Midway City Council  
3 September 2019  
Regular Meeting

Watts Remund Farms PUD /  
Master Plan Amendment

## CITY COUNCIL MEETING STAFF REPORT

**AGENDA ITEM:** Master Plan Amendment

PHASING MASTER PLAN

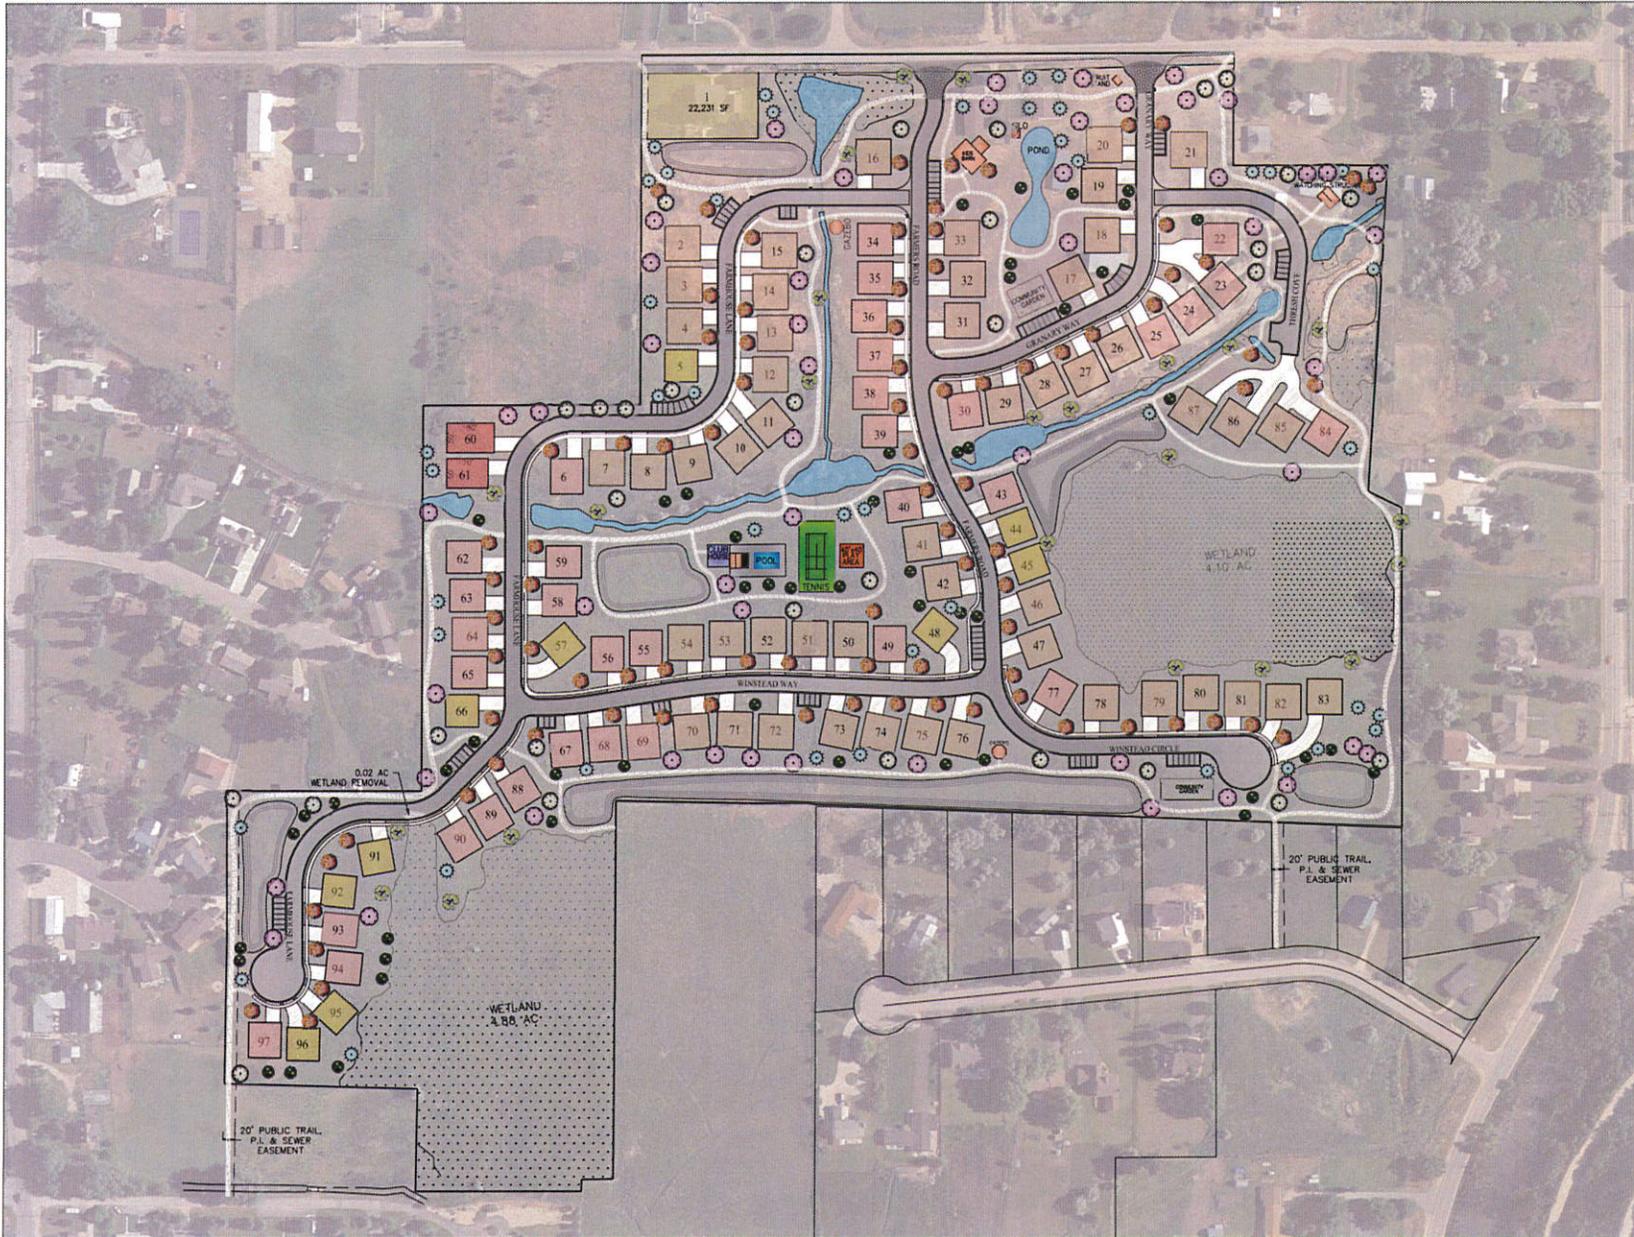
Paul Berg is proposing Master Plan amendment of Remund Farms Planned Unit Development (PUD) which would replace the existing master plan that was approved on March 28, 2018. The applicant is proposing three changes from the approved plan. The first is to replace phases 2 and 3 into seven phases which would bring the total number of phases in the master plan to eight. The second is to add 37 limited common areas behind some of the building pads. The third is to adjust the driveway and dimensions of building pad 84.

WATTS ENTERPRISES  
 REMUND FARMS  
 AMENDED PHASING PLAN

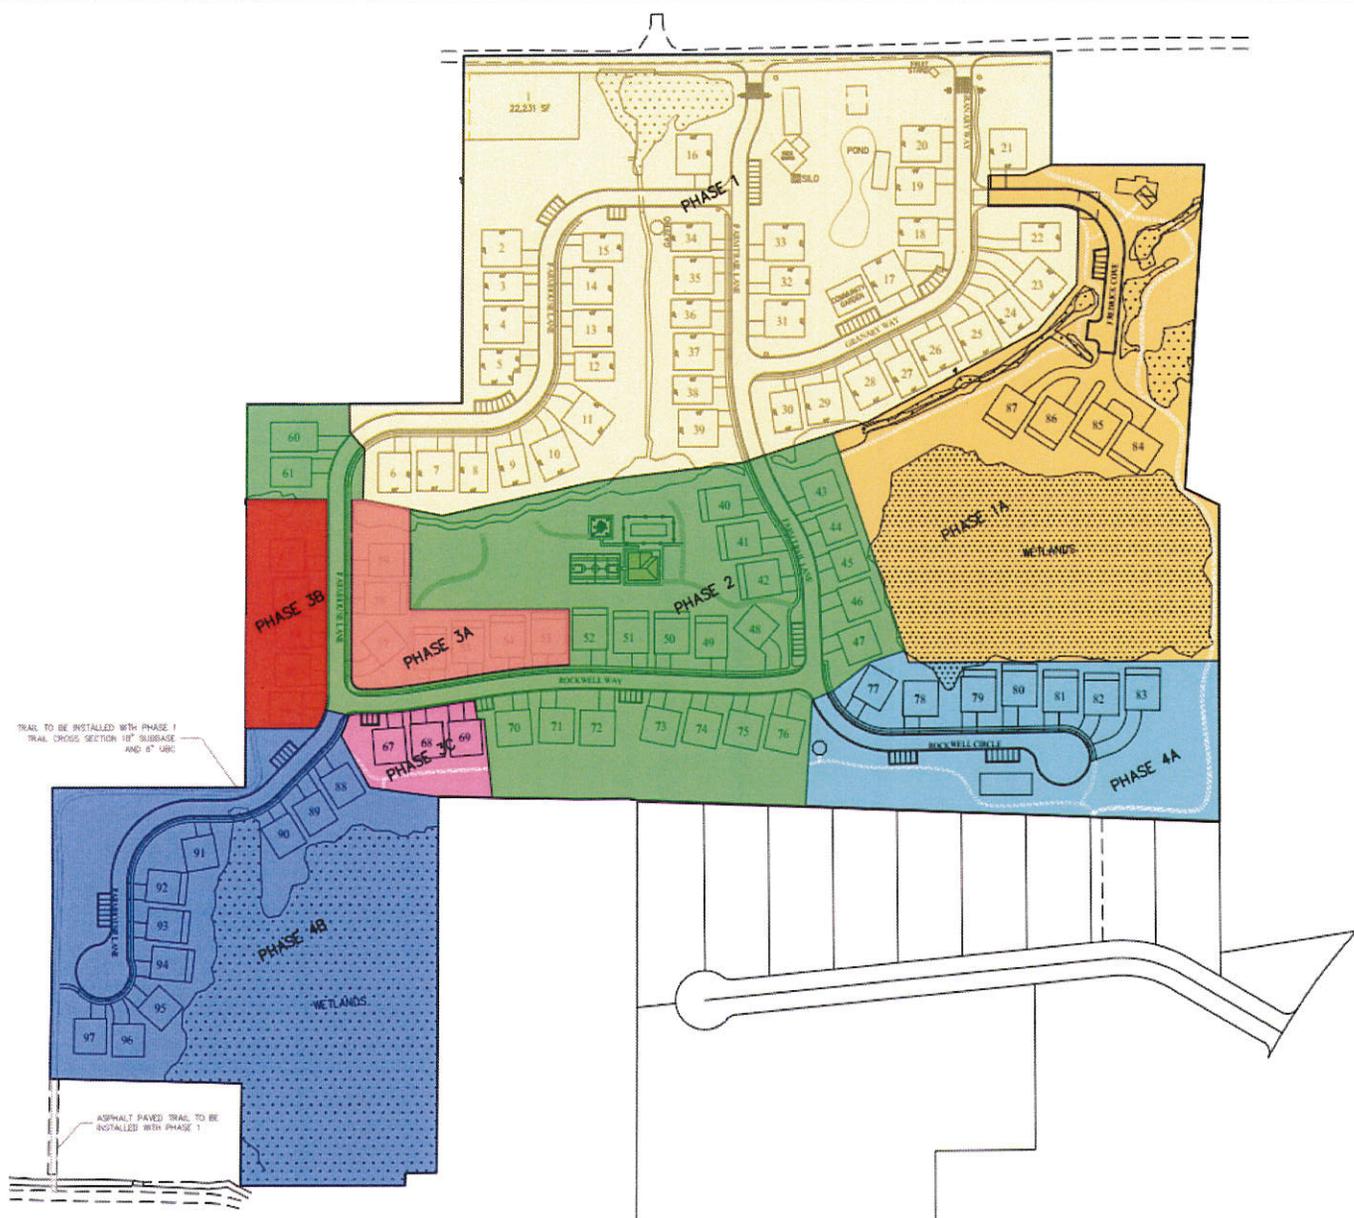
*Additional phases* – The proposed amendment would increase the number of phases in the development from three to eight and eight plats would be recorded, one per phase. Two of the phases are small in that one has three pads, and another has four pads. This change does create some advantages to the developer such as tax benefits. The developer will pay full taxes on each phase when the plat is recorded. Increasing the number of plats will delay paying as much for taxes per phase as compared to the approved master plan. Creating more plats also reduces developmental risk. If there is an economic downturn after a plat is recorded, then those lots will most likely not sell for some years. The developer will pay taxes on all pads in the phases but if the phases have less units then taxes are less.

There are some impacts for staff that should be considered. The first is this change will add more work for staff and increase the number of public meetings before the Planning Commission and the City Council. Instead of reviewing three plats for Remund Farms PUD there will be eight plats. Each plat would need to be reviewed by planning department, city recorder, county surveyor, and then the city recorder's office would need to gather all those who sign the plats which is a time-consuming process that usually takes a few weeks. Regarding the number of public meetings that will increase; the current three phase master plan generates at a minimum 12 public meetings, six for the Planning Commission and six for the City Council. The proposed amendment would increase that number to 32 public meetings. The Water Board will most likely have more meetings with the phases of this master plan on their agenda. Staff feels the City may want to consider requiring a minimum number of lots/units per phase in a phased development to avoid an excessive number of meetings and time required for each phase.

**Motion:** Commissioner Ream: I move that we approve the proposed master plan amendment 3 changing the number of phases from 3 to 6 by combining 3a, 3b and 3c into one phase. Accept staff findings and one condition of recording all the phases with sequential numbering from 1 to 6.
